ADDENDUM NO. 2

TO: All Holders of Plans and Contract
Documents for Hwy 54 Sidewalk Improvements
Project, Phase I, TAP-9900(749)
El Dorado Springs, Missouri

ISSUED: December 8, 2015

7.2 TYPE "B" ADA RAMP DETAIL
N.T.S.

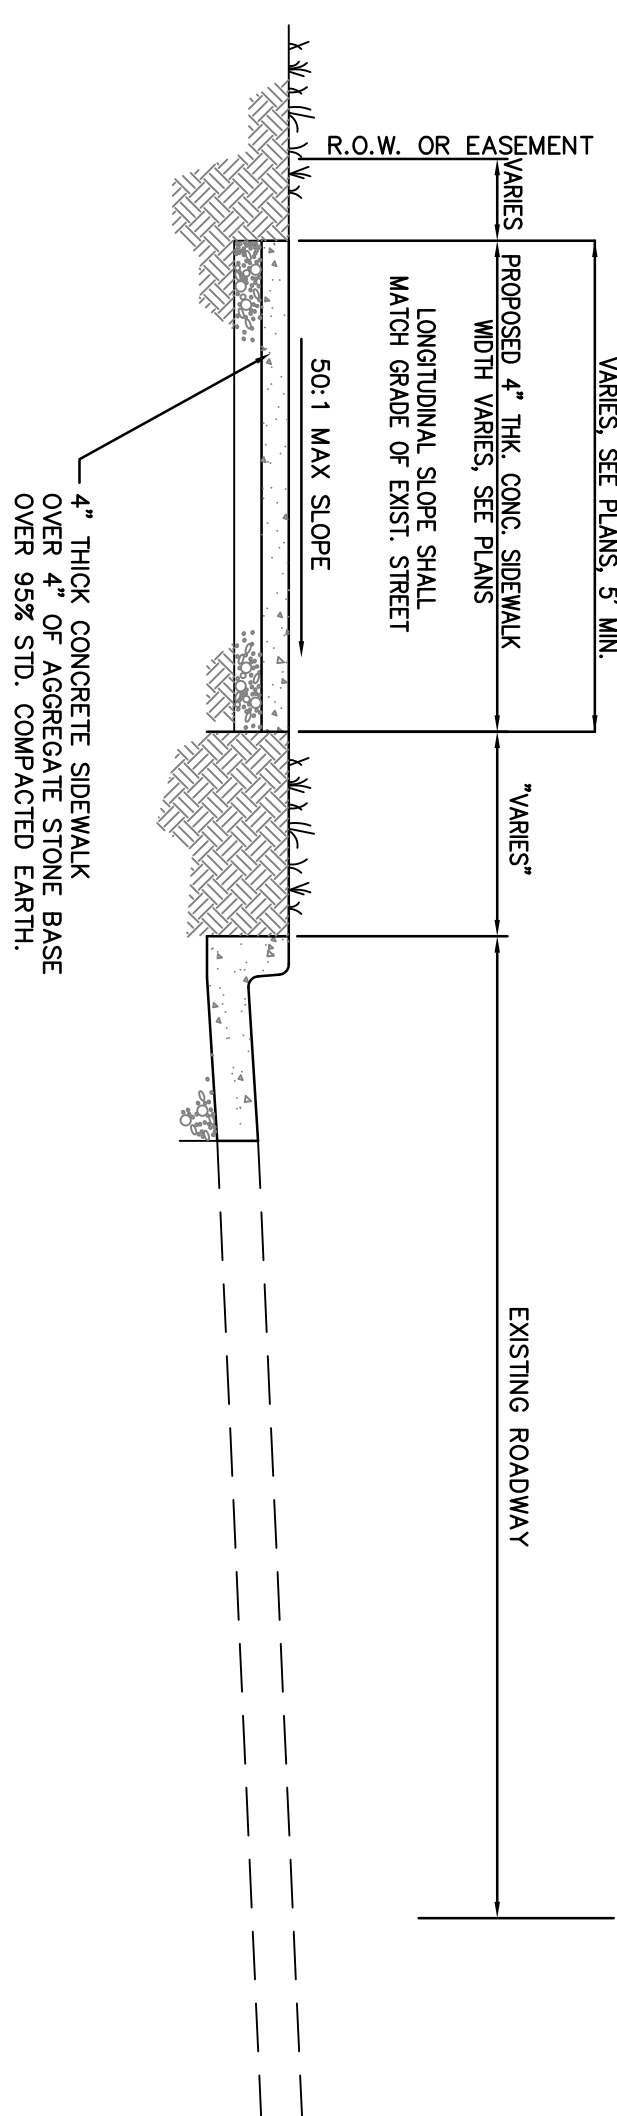
- 3) Sheet 13 of the plans is hereby replaced with the attached revised Sheet 13. The following changes to this sheet were made:
 - a. Deleted Detail 7.1 *Type "A" ADA Ramp Plan Detail*. All ramps on project shall hereby be changed to *Type "B" ADA Ramps* as shown in Detail 7.2.

- 4) Sheets 4-11: All Type "A" Ramps labeled shall be changed to Type "B" Ramps.

7.7 CONCRETE SIDEWALK, 8" THICK ACROSS DRIVES
N.T.S.

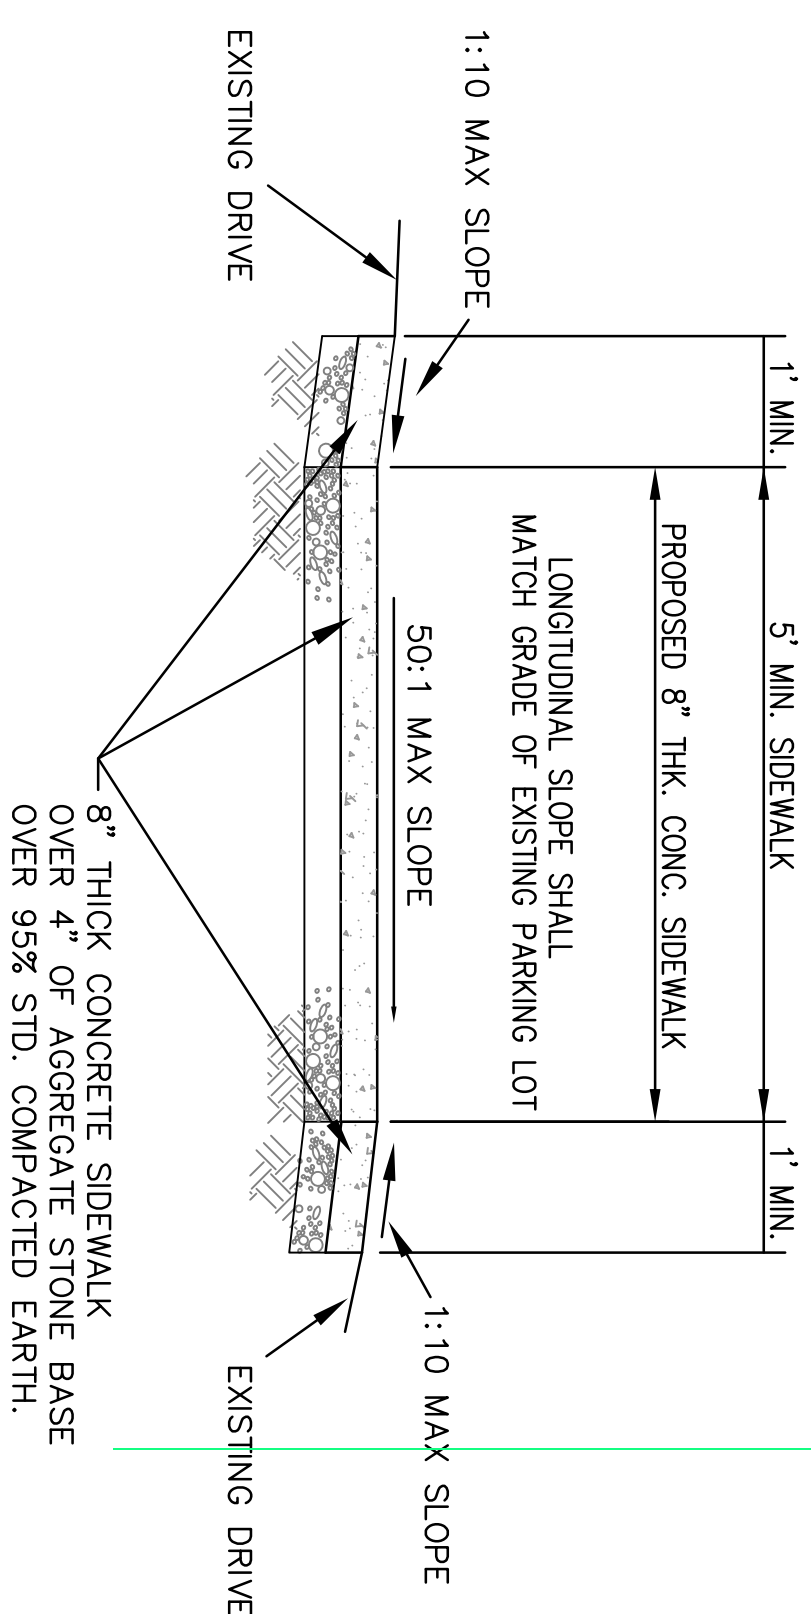
- b. Revised Detail 7.7 to *Concrete Drives, 8" Thick Across Drives*.
 - c. Deleted Detail 7.8 *Sidewalk Drain*
 - d. Moved notes below Detail 7.9 to below Detail 7.6
